**ADDENDUM 01**

Addendum #	01	Date Issued	03/21/2025
Project Name Job #	SWN 0509, Waneta Hall Renovate Restrooms	OSE #	R0325--15X
		EAPC #	20256780
Bid Date Time	April 3, 2025		3:30pm

PROJECT DESCRIPTION
SWN 0509, WANETA HALL RENOVATE RESTROOMS (OSE# R0325--15X)

DRAWING TITLE
DEMOLITION PLAN - FIRST FLOOR

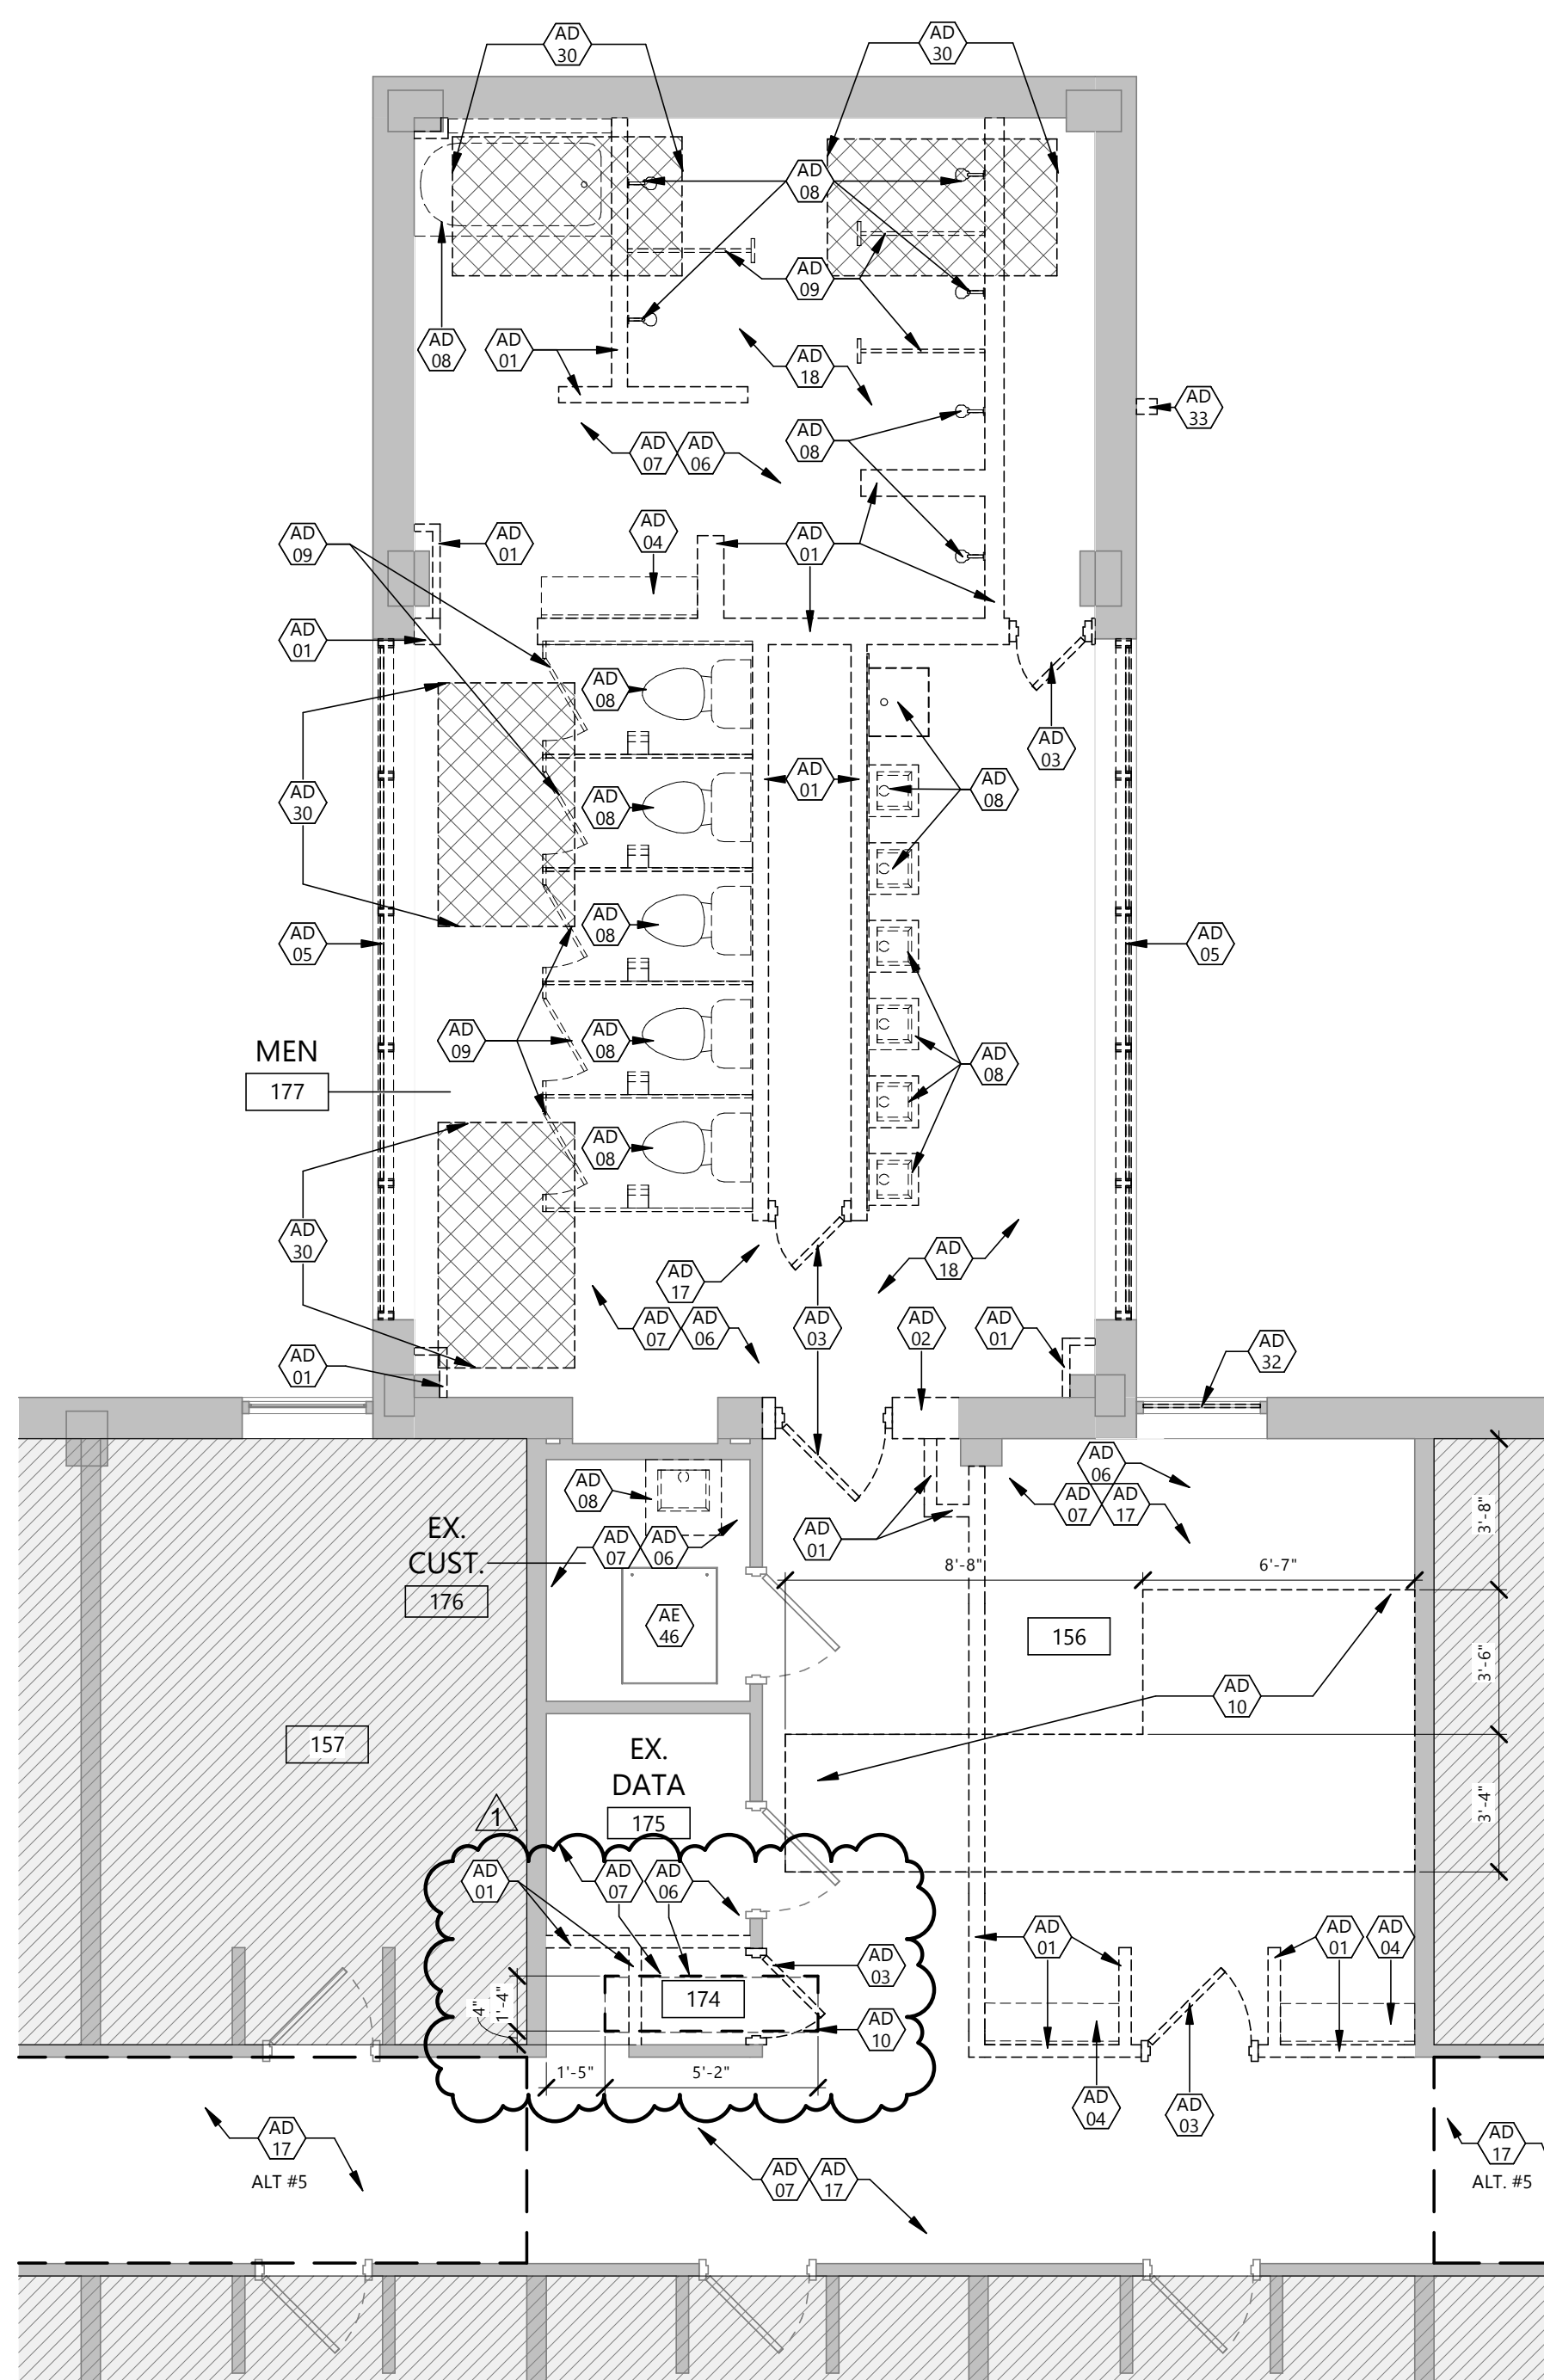
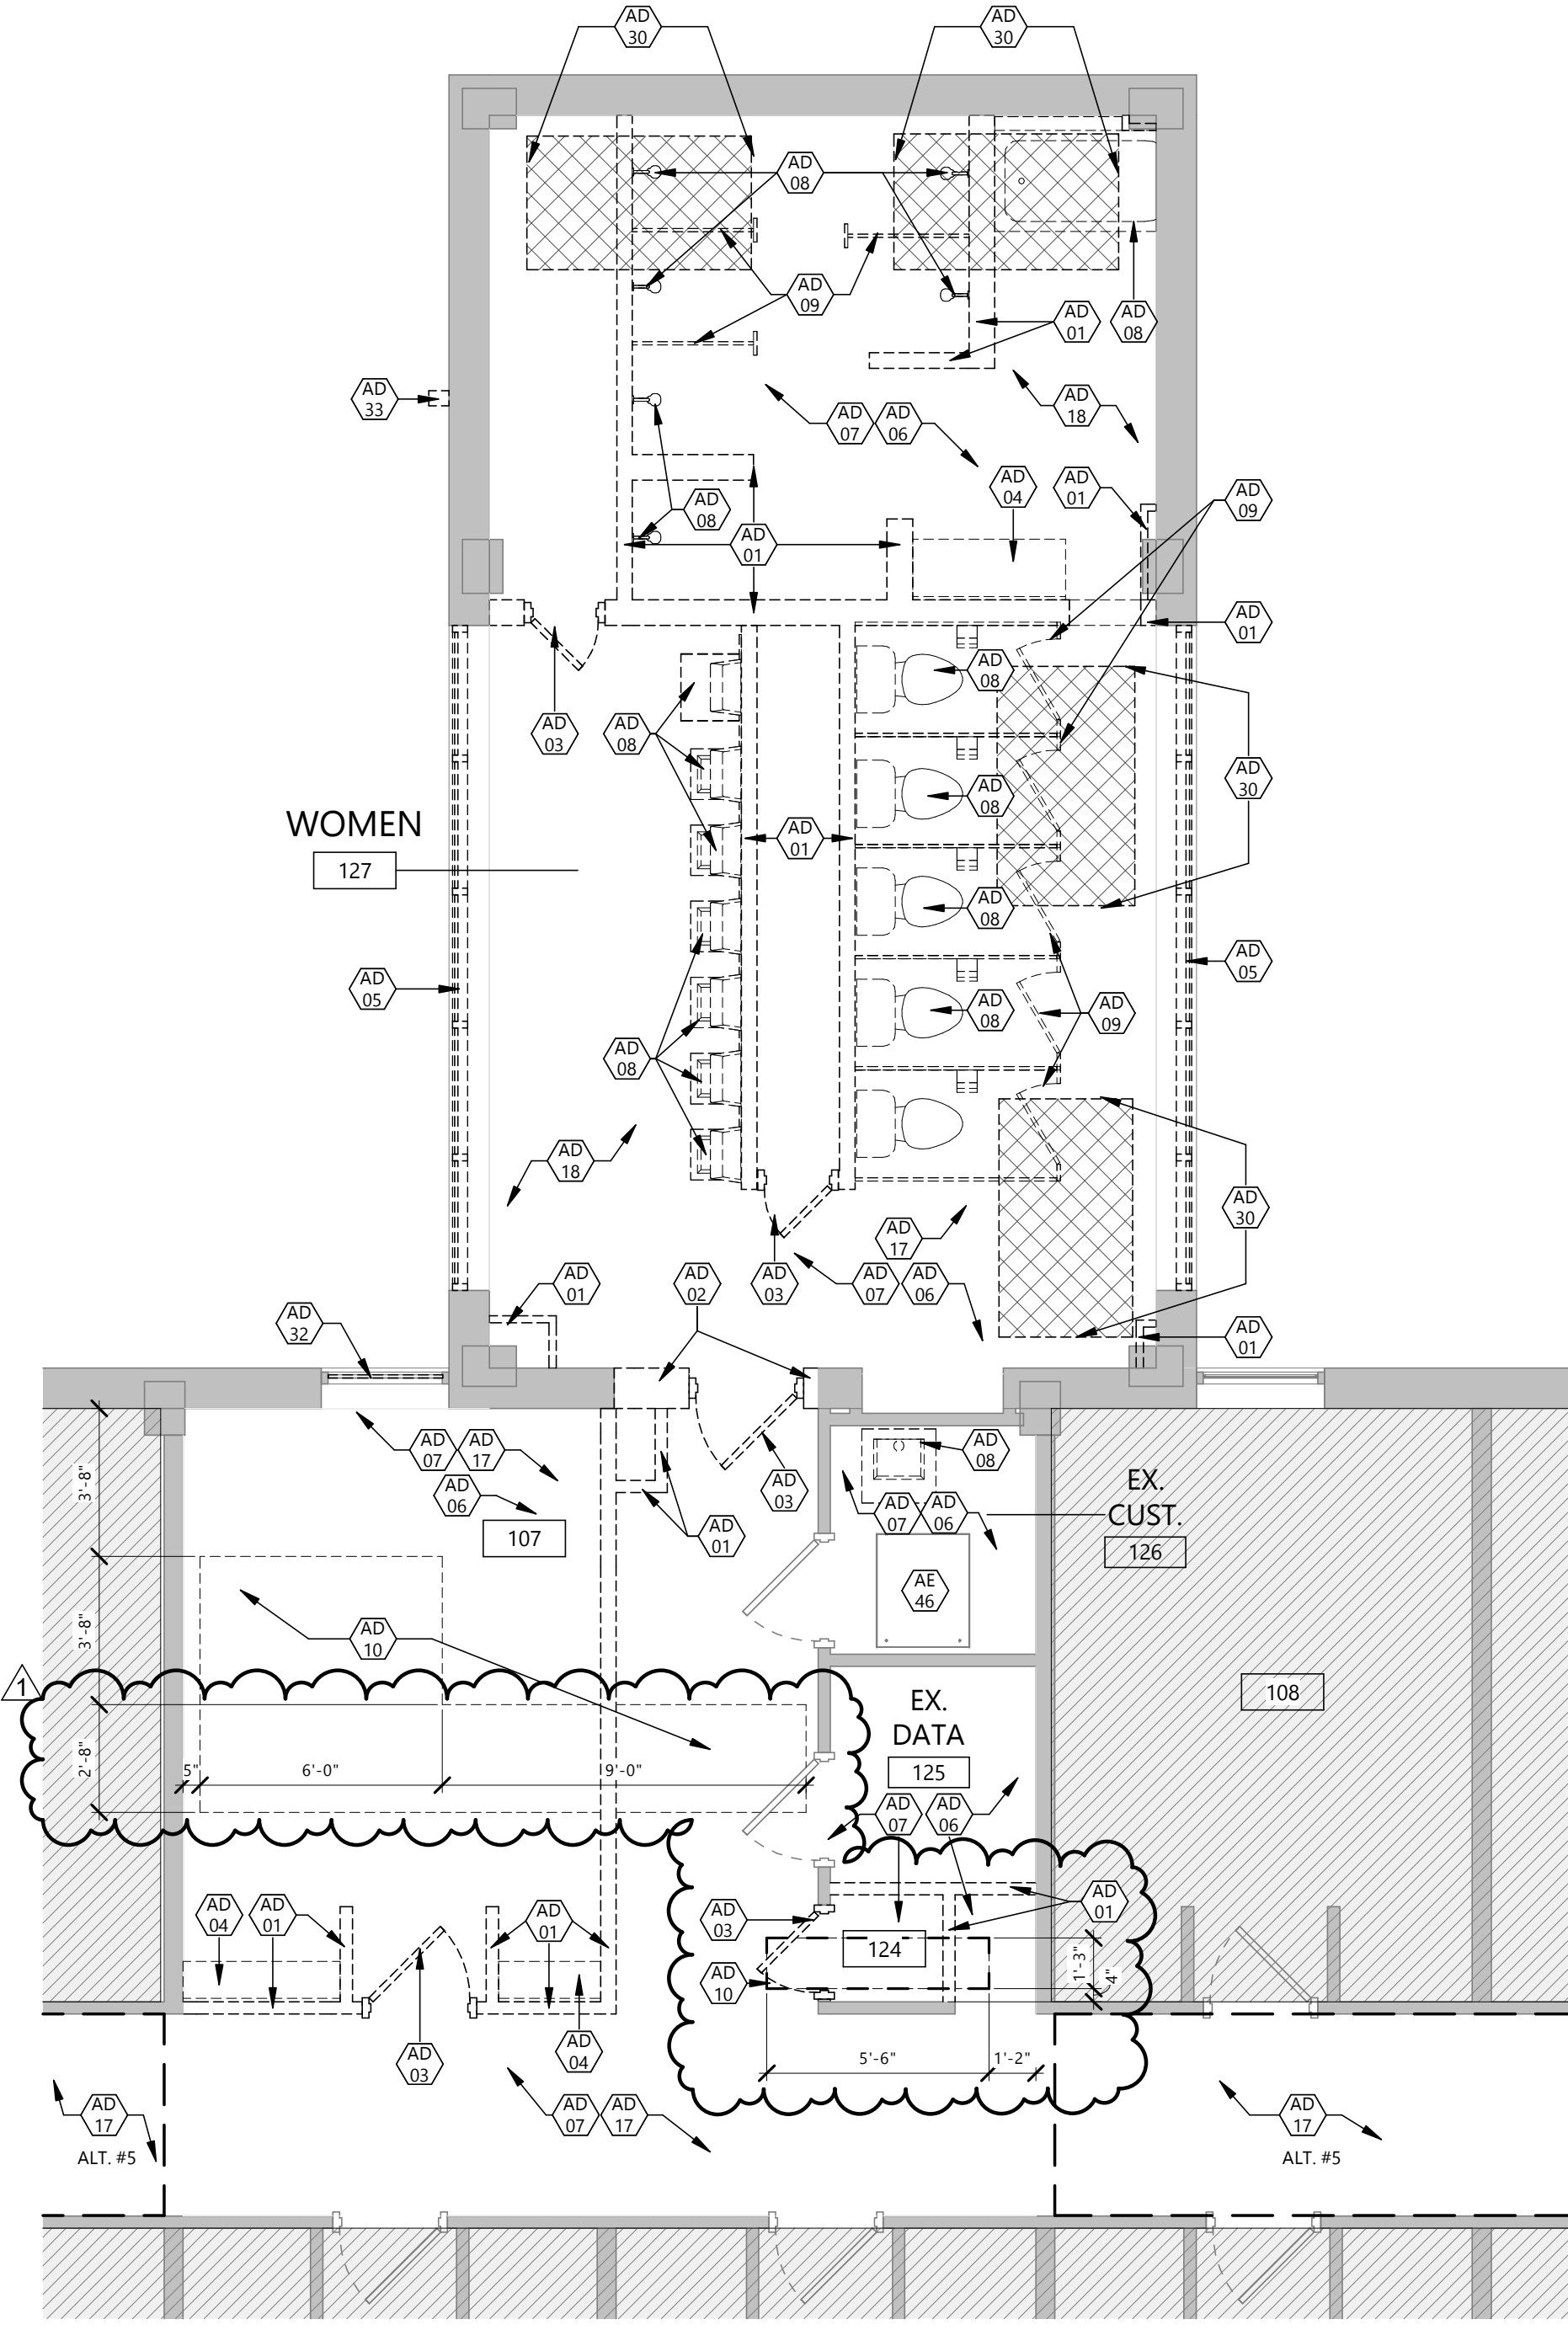
A101	REVISE extents of concrete demolition. REVISE Keynote AD 10.
A200	ADD Keynote AE 35.
A201	REVISE extents of concrete pad. REVISE Keynotes AE 35 & AE 52.
A301	REVISE Issue Date. REVISE General Ceiling Note #6. ADD Keynotes AE 02 and AE 03. Revise ceiling and lighting layouts in rooms 125, 175 and the hallways around the new construction.
A302	REVISE General Ceiling Note #6. ADD Keynote AE 03. Revise lighting layouts in the hallways around the new construction. ADD notes for extents of Alt. #5 on 1/A302.
A303	REVISE General Ceiling Note #6. ADD Keynote AE 03. Revise lighting layouts in the hallways around the new construction.
A304	REVISE issue date. REVISE lighting layout on at the student space 102. Extend wall in Kitchen 130 to ceiling.

- AD 09 REMOVE EXISTING PARTITION SYSTEM
- AD 10 DEMOLISH PORTION OF FLOOR SLAB FOR PLUMBING INSTALLATION. COORDINATE EXACT SIZE AND LOCATIONS WITH MC. SEE A021 FOR SLAB INFILL.
